Chapter 2. Response to Comments on the Public Review Draft MND

This memo contains responses to the comments that the City of San Bernardino (Lead Agency) received on the Mitigated Negative Declaration (MND) for the Hardt and Brier Business Park Project during the public review period, which began November 1, 2023, and closed November 20, 2023 (SCH No. 2023100916). This document has been prepared in accordance with California Environmental Quality Act (CEQA) as amended (Public Resources Code Section 21000 et seq.) and the State CEQA Guidelines (Cal. Code Regs., tit. 14, § 15000 et seq.) and represents the independent judgment of the Lead Agency. This document and the circulated MND together comprise the Final MND.

Re: Comment on the Mitigated Negative Declaration (MND) for the Hardt and Brier Business Park Project (SCH No. 2023100916); Development and Environmental Review Committee December 13, 2023 Meeting Agenda Item No. 2

Figure 9: Preferred Bikeway Type for Urban, Urban Core, Suburban and Rural Town Contexts

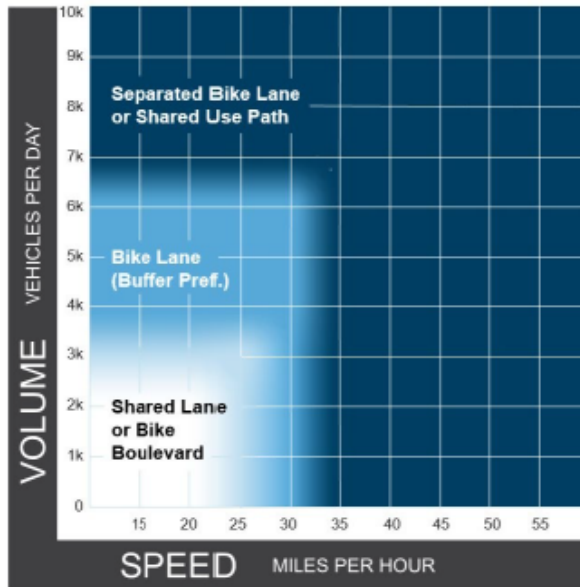
The second concerns is to ensure that the appropriate bike facilities per [the Caltrans guidelines](#) (or similar from FHWA or NACTO) are built.

Response to Comment 1.2: This comment states that the commentor has concerns over ensuring that appropriate bike facilities, per Caltrans guidelines, are built.

This comment does not raise a specific issue with the adequacy of the MND or raise any other CEQA issue. The MND discusses alternative transportation in Section 5.17, *Transportation*, page 133 of the MND and states that the proposed Project would provide on-site bicycle parking and would not conflict with alternative transportation such as transit, bicycle, and pedestrian facilities. According to the Final San Bernardino Active Transportation Plan *Bicycle Network* map, Tippecanoe Avenue, east of the Project site, is a proposed Class II bike lane and East Brier Drive is a proposed neighborhood street. No existing bicycle network is located near the Project site. The commentor also refers to Caltrans, NACTO, and FHWA guidelines for bike facilities; however, the provided guidelines are guidance tools and are not required of the proposed Project. According to the Caltrans Contextual Guidance for Bike Facilities Memorandum, attached to the comment letter, the contextual guidance chart does not replace engineering judgement or design standards and it should be used as a decision support tool for scoping active transportation facilities during the project planning phase and identifying corridor-level bicycle needs. The proposed Project is consistent with the required bicycle infrastructure from the City of San Bernardino and has incorporated the appropriate facilities into project plans. Therefore, no further response is required or provided.

Figure 1. Actual and predicted relationships between the number of vertebrate wildlife species detected and the elapsed survey time based on Noriko’s visual-scan survey on 23 November 2023. Note that the relationship would differ if the survey was based on another method or during another season.

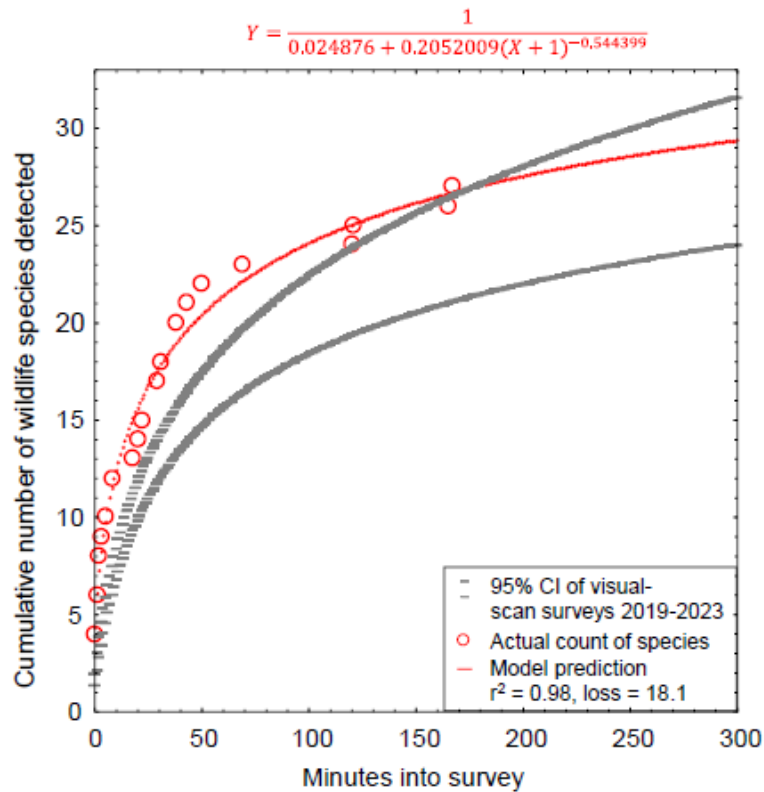
I fit a nonlinear regression model to Noriko’s cumulative number of vertebrate species detected with time into her survey to predict the number of species that she would have detected with a longer survey or perhaps with additional biologists available to assist her. The model is a logistic growth model which reaches an asymptote that corresponds with the maximum number of vertebrate wildlife species that could have been detected during the survey. In this case, the model predicts 40 species of vertebrate wildlife were available to be detected on the morning of the 23rd, which left 13 species undetected during her survey (Figure 1). Unfortunately, I do not know the identities of those 13 species Noriko missed, but the pattern in her data indicates relatively high use of the project site compared to 53 surveys at other sites she and I have completed in the region. Compared to models fit to data I collected from 53 other sites in the region between 2019 and 2023, the data from the New Hardt project site mostly exceeded the upper bound of the 95% confidence interval of the rate of accumulated species detections with time into the survey (Figure 1). Importantly, however, the species Noriko did and did not detect on November 23 composed only a fraction of the species that would occur at the project site over the period of a year or longer. This is because many species are seasonal in their occurrence.

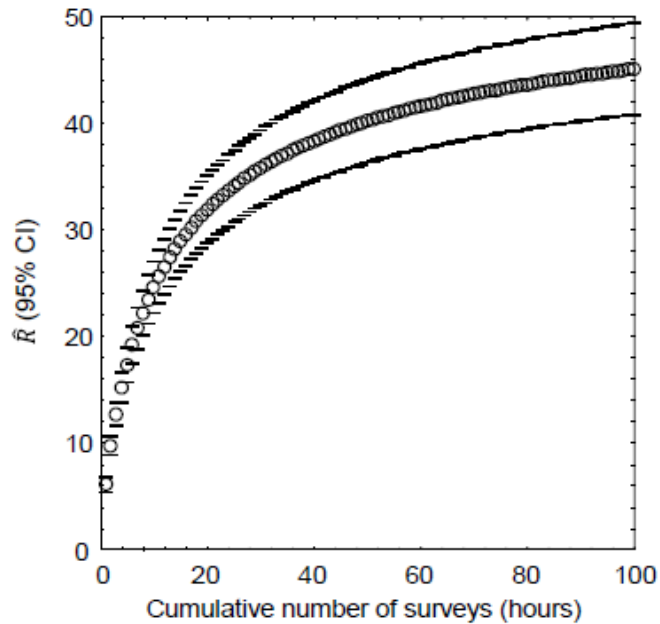
I projected the predictions of each model to thousands of hours to find predicted asymptotes of wildlife species richness. The mean model-predicted asymptote of species richness was 57 after 11,857 hours of visual-scan surveys among the 46 stations of my research site. I also averaged model predictions of species richness at each incremental increase of number of surveys, i.e., number of hours (Figure 2). On average I would have detected 13.2 species over my first 3.18 hours of surveys at my research site in the Altamont Pass (3.18 hours to match the 3.18 hours Noriko surveyed at the project site), which composed 23.15% of the predicted total number of species I would detect with a much larger survey effort at the research site. Given the example illustrated in Figure 2, the 27 species Noriko detected after her 3.18 hours of survey at the project site likely represented 23.15% of the species to be detected after many more visual-scan surveys over another year or longer. With many more repeat surveys through the year, Noriko would likely detect $27 / 0.2315 = 117$ species of vertebrate wildlife at the site. Assuming Noriko's ratio of special-status to non-special-status species was to hold through the detections of all 117 predicted species, then continued surveys would eventually detect 22 special-status species of vertebrate wildlife.

Because my prediction of 117 species of vertebrate wildlife, including 22 special-status species of vertebrate wildlife, is derived from daytime visual-scan surveys, and would detect few nocturnal mammals such as bats, the true number of species composing the wildlife community of the site must be larger. Noriko's reconnaissance survey should serve only as a starting point toward characterization of the site's wildlife community, but it certainly cannot alone inform of the inventory of species that use the site. More surveys are needed than her one survey to inventory use of the project site by wildlife.

Nevertheless, the large number of species I predict at the project site is indicative of a relatively species-rich wildlife community that warrants a serious survey effort.
